Section 57 Declaration – Works to a Protected Structure

Reference No: S57 LHS24-04

Description: Proposal to upgrade the 3-no. leaking asphalt clad flat roofs.

Location of Development Saint Brigid's Hospital, Kells Road, Ardee, Co. Louth A92 DRN0

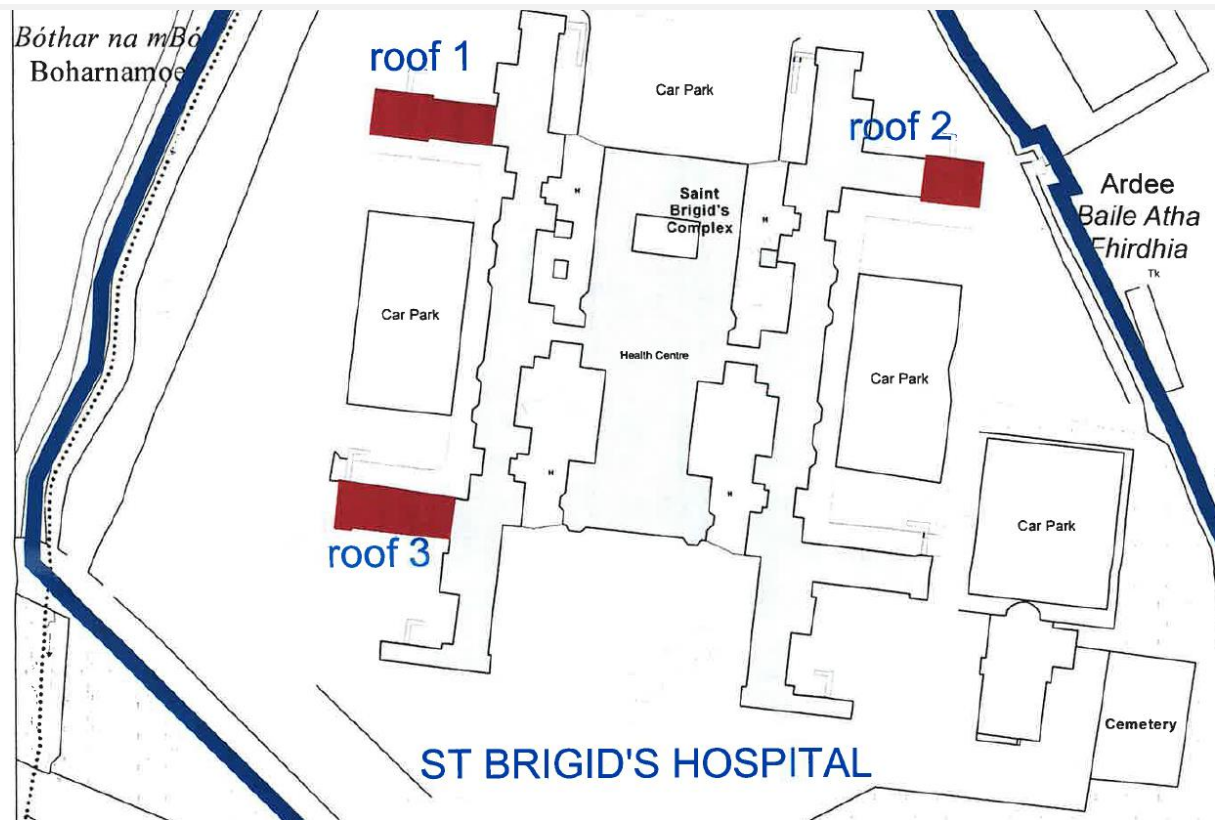
The 3no. roofs top returns have failed and as a result water ingress is seeping to internal parts in the building below and resulting in degradation of interior parts.

The 3no. flat roofs involved are identified above.

Having reviewed the proposals, I conclude that the works involve repair, maintenance and upgrade of the 3no. roofs to bring them into a state of good repair would not materially affect the character of the protected structure.

View of salvaged brick used in sample parapet

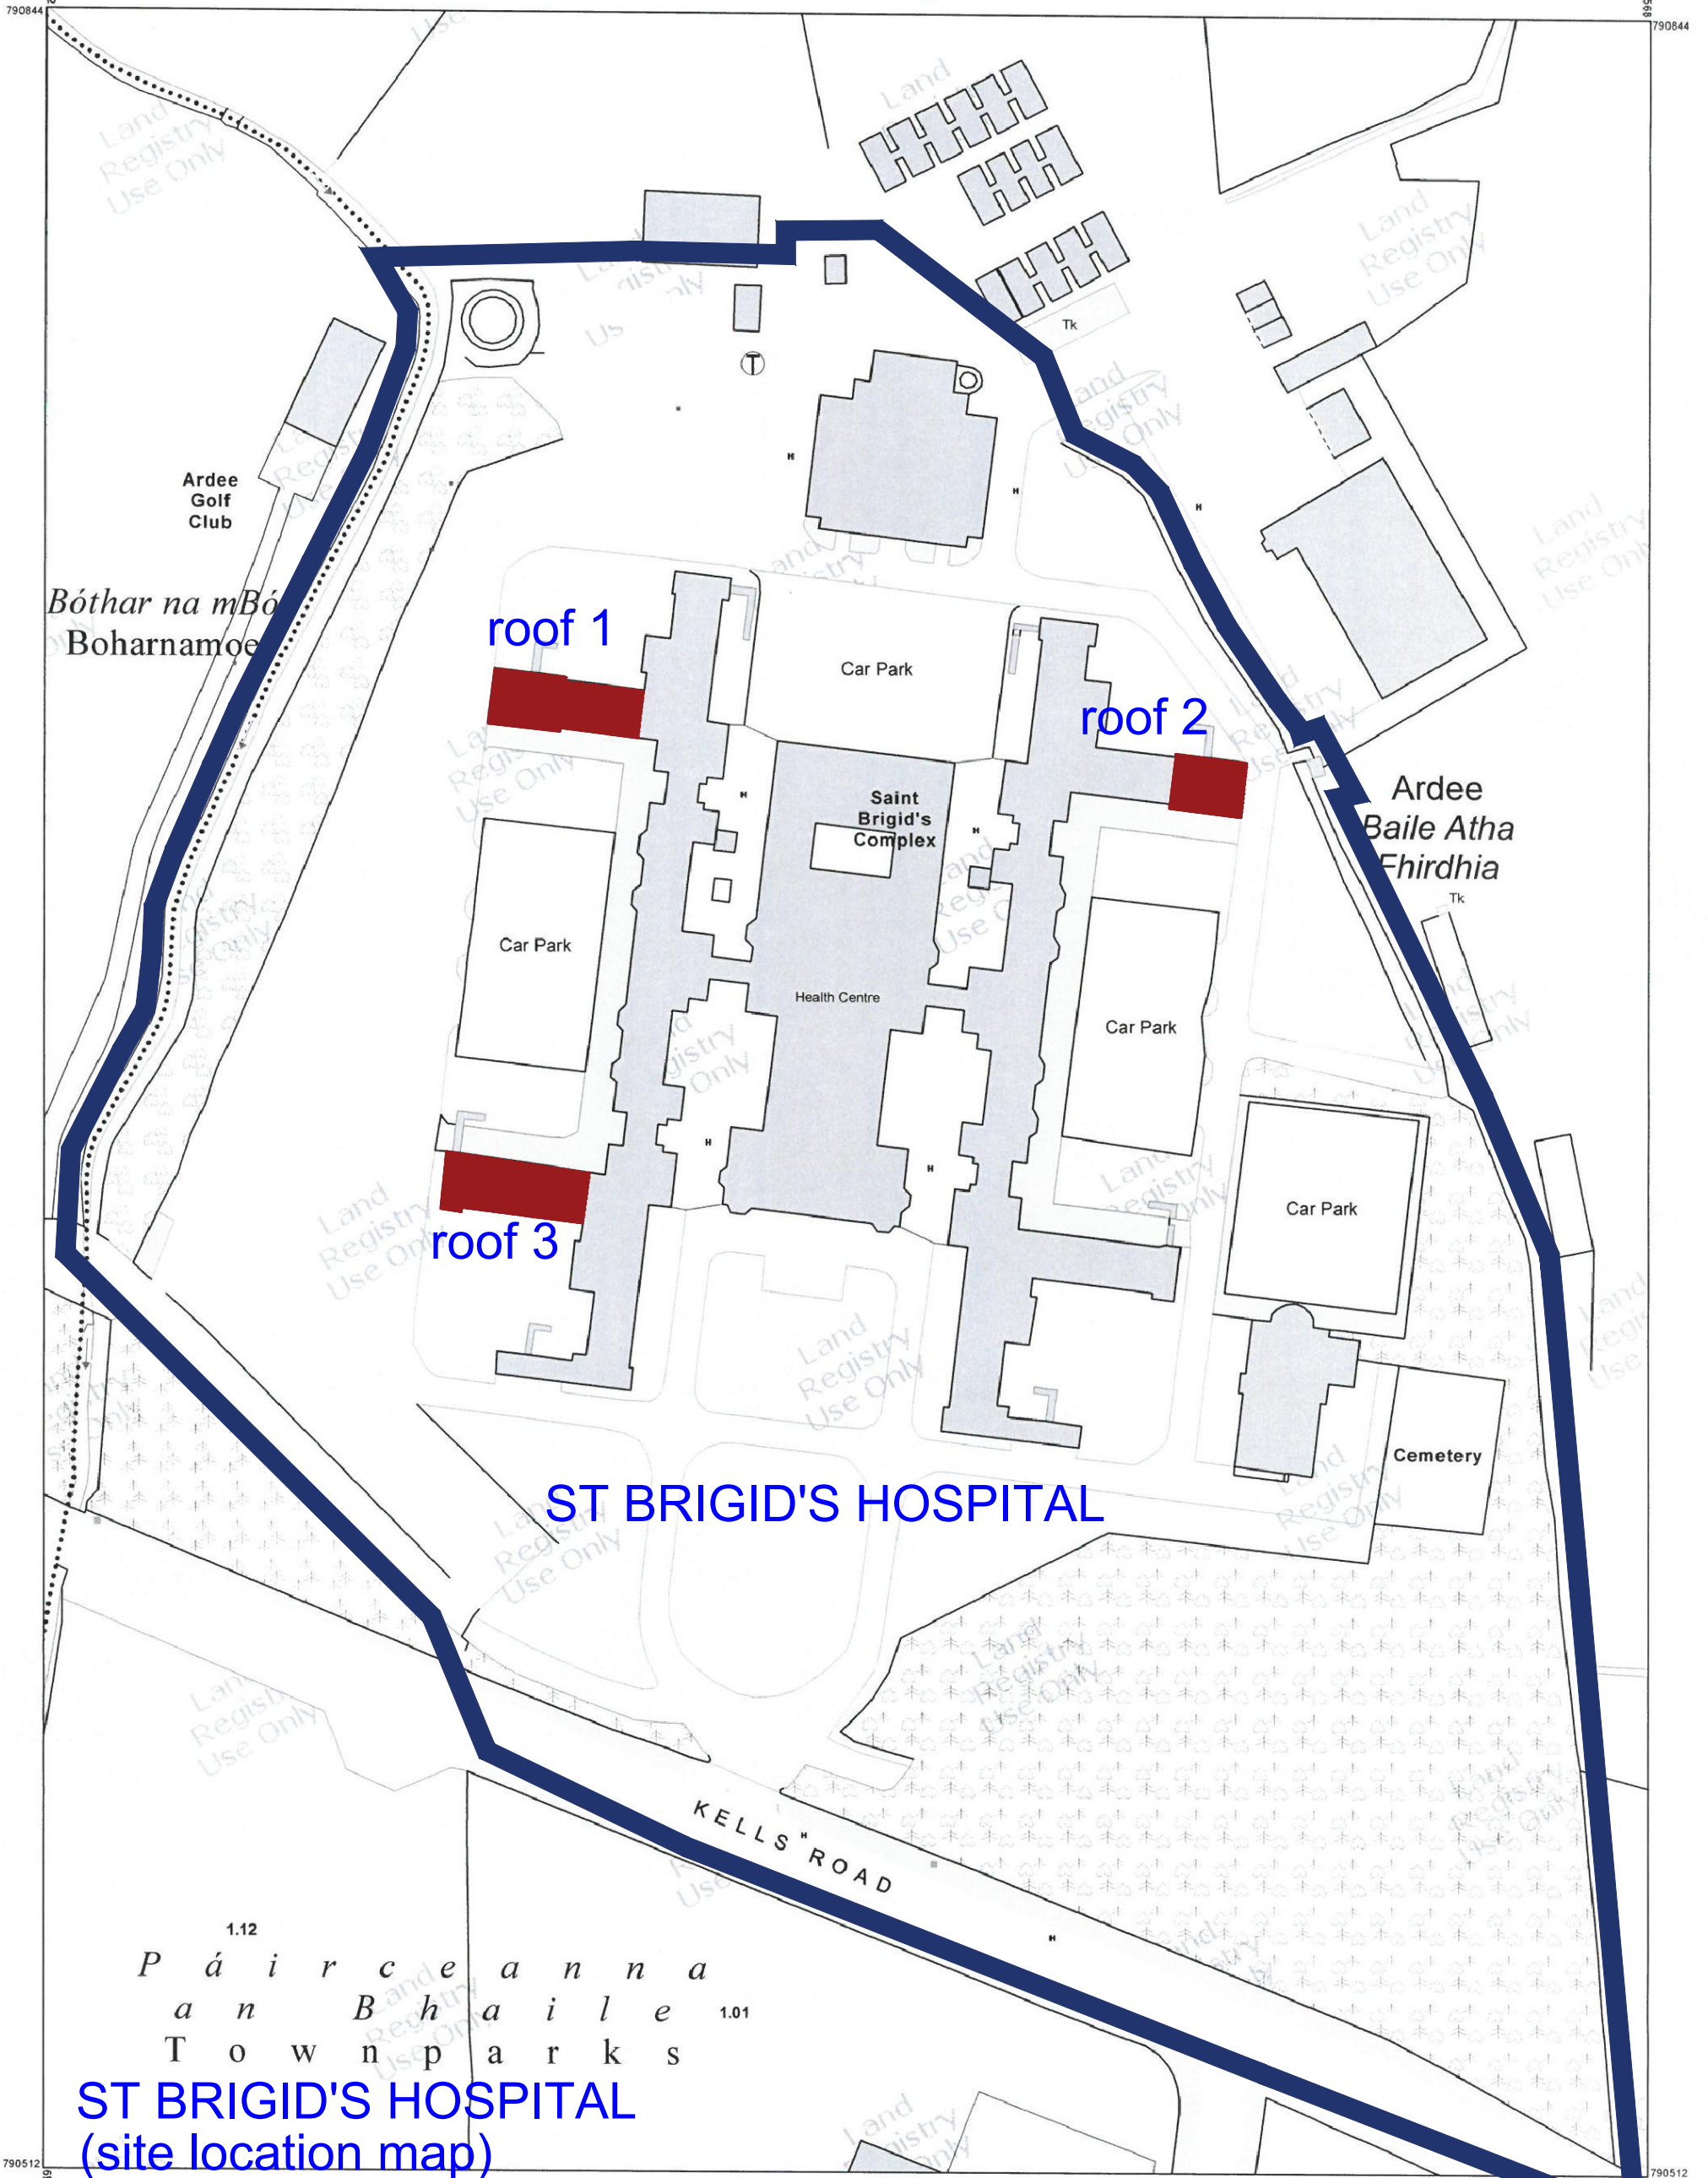
However, on commencement of the removal of the parapet walls it was noted the brick work parapet walls at St. Brigid's Hospital are constructed using sand cement mortar. This has resulted in the mortar being secured to the brick work. It is not possible to remove the mortar from the brick work without causing irreparable damage to the clay parapet bricks.

The brick is of good quality is of similar size to the existing brick work in the parapet walls, while the brick is a near match to the existing parapet walls.

The builder on site has reconstructed a sample section of parapet wall using the Normanton brick (refer to attached photographs).
